## KHNP Response to Issues - DCD Section 3.9.4

## **KHNP Response to Issues - DCD Section 3.9.4**

Figure 3.9-7 Control Element Drive Mechanism

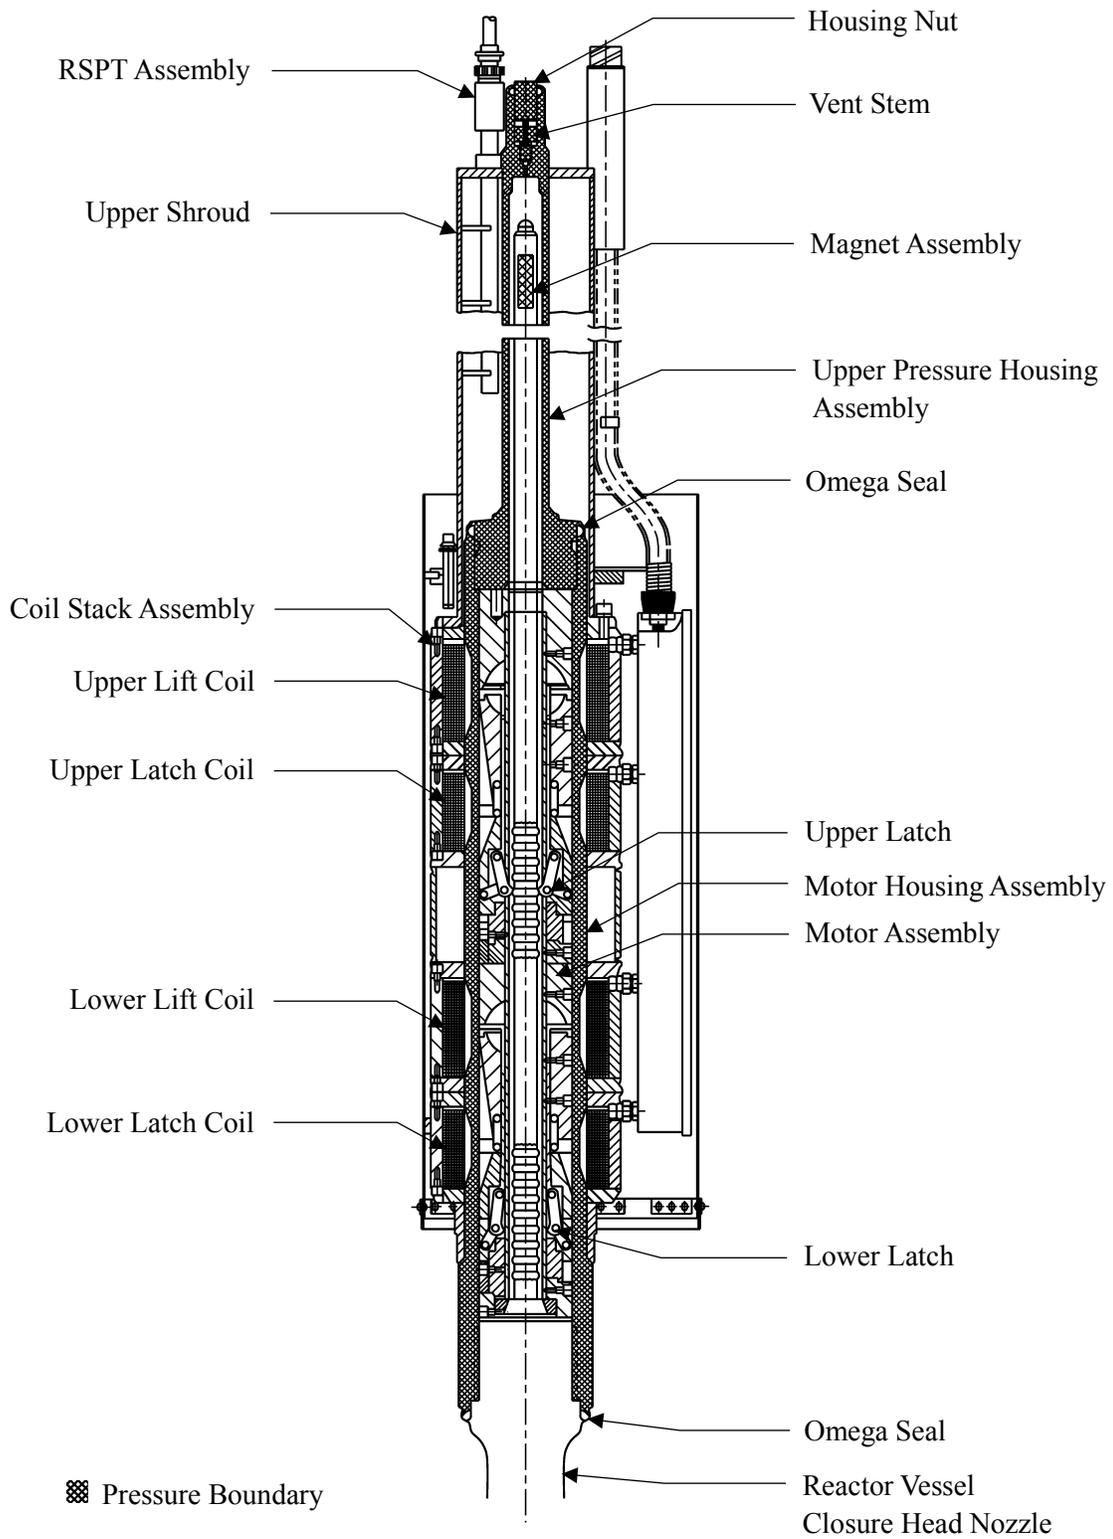
The staff requests the applicant to update the Figure 3.9-7, "Control Element Drive Mechanism" to clearly indicate the components that form the pressure boundary, including the motor housing assembly. This information is necessary to complete the area of review described in SRP 3.9.4, Item I.1, which states that "[t]he descriptive information, including design criteria, testing programs, drawings, and a summary of the method of operation of the control rod drives, is reviewed to permit an evaluation of the adequacy of the system to perform its mechanical function properly."

Figure 3.9-7 for the Control Element Drive Mechanism will be updated to clearly indicate the pressure boundary components.

Figure 3.9-7 will be revised as indicated on the attached markup.
